Verano Development of Regional Impact (DRI) Preliminary Master Plan, Map H Amendment (P22-215)

Holly Price, AICP, Senior Planner City Council September 26, 2022

Map H Proposed Changes

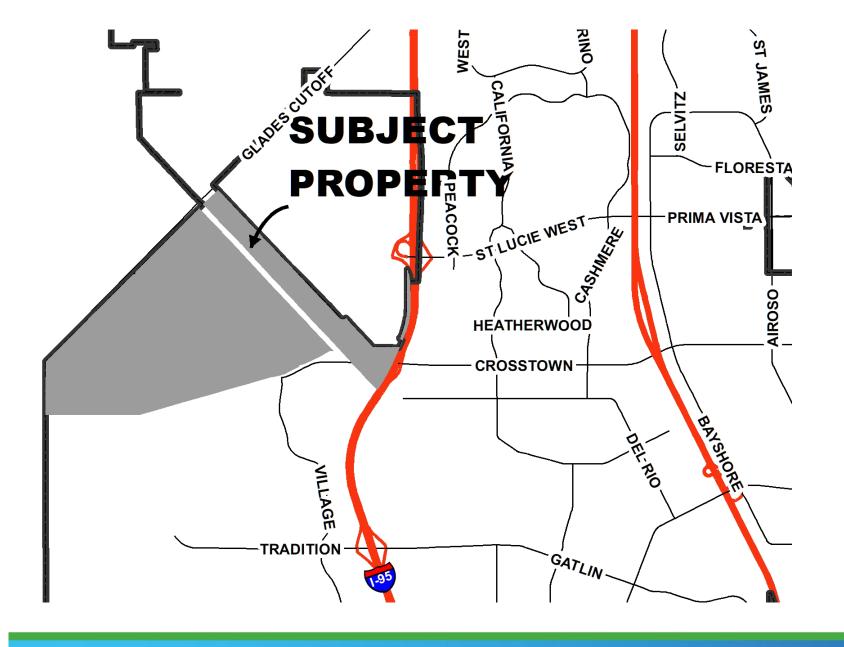
- City park site Reconfigured shape of site. Previously extended along entire length of Range Line Road.
- Added a commercial site at corner and added lake along Range Line Road.
- County school site Relocated next to City park site.
- Added 80' ROW for school.
- Remove Murphy triangle property from the map.
- Remove access from Glades Cut-off Road.

Distances from Range Line Road

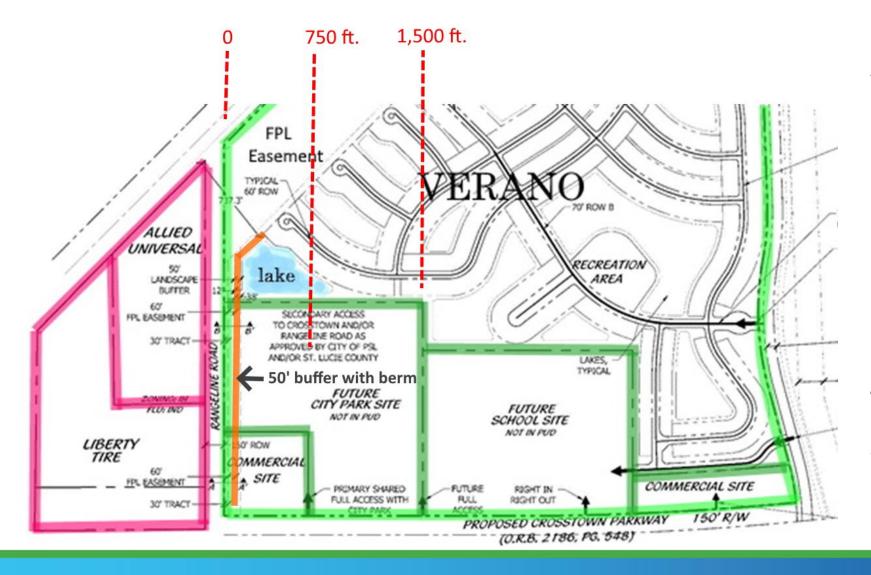
Total minimum distance from industrial buildings = 250' (setback + right-of-way)

Buffer Distance from Range Line Road to City Park Site = 30' +60' + 38' = 128'

Total distance from industrial buildings + Range Line Road ROW + Verano Buffer = 250' (setback + right-of-way) + 128' = 378'

Closest Residential Use to industrial properties, approximate = 250' + 400' = 650' min.

The buffer issue is planned to be discussed in greater detail when the PUD is reviewed.
